**Report: TAB REPORT**  
**Function: Test, Adjust, & Balance**  
**Date: 04/05/2023**

**03-27-23 FREDDY'S - JASPER, AL**

Project: 03-27-23 FREDDY'S - JASPER, AL

KEF1Duct.jpeg

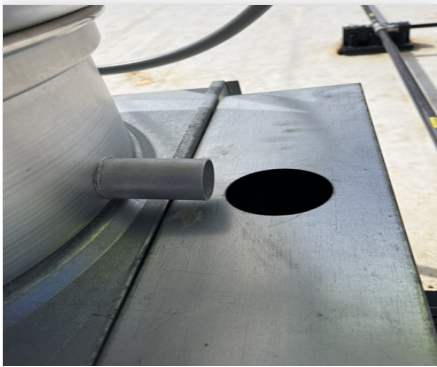
**Issue Name :** \*NON-CRITICAL\* KEF1 grease ductwork does not have fyrewrap material  
**Description :** (RESOLVED) Shown on M3.0 kitchen hood exhaust fan detail 3. Duct is not protected with materials as approved for 1 hour fire resistance.  
**Created By :** National TAB **Assigned To :** National TAB - Will Turnbough  
**Status :** Closed  
**Originated Date :** 03/29/2023 - Ian Fuller - National TAB

KEF2DrainPipe.jpeg

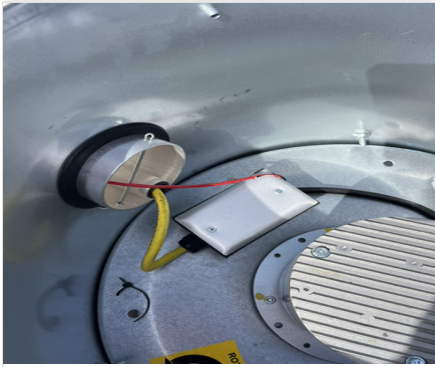
**Issue Name :** \*NON-CRITICAL\* KEF2 drain pipe is not centered to drain pain.  
**Description :** Recommended to install pvc pipe into center of hole.  
**Created By :** National TAB **Assigned To :** National TAB - Will Turnbough  
**Status :** Open  
**Originated Date :** 03/29/2023 - Ian Fuller - National TAB
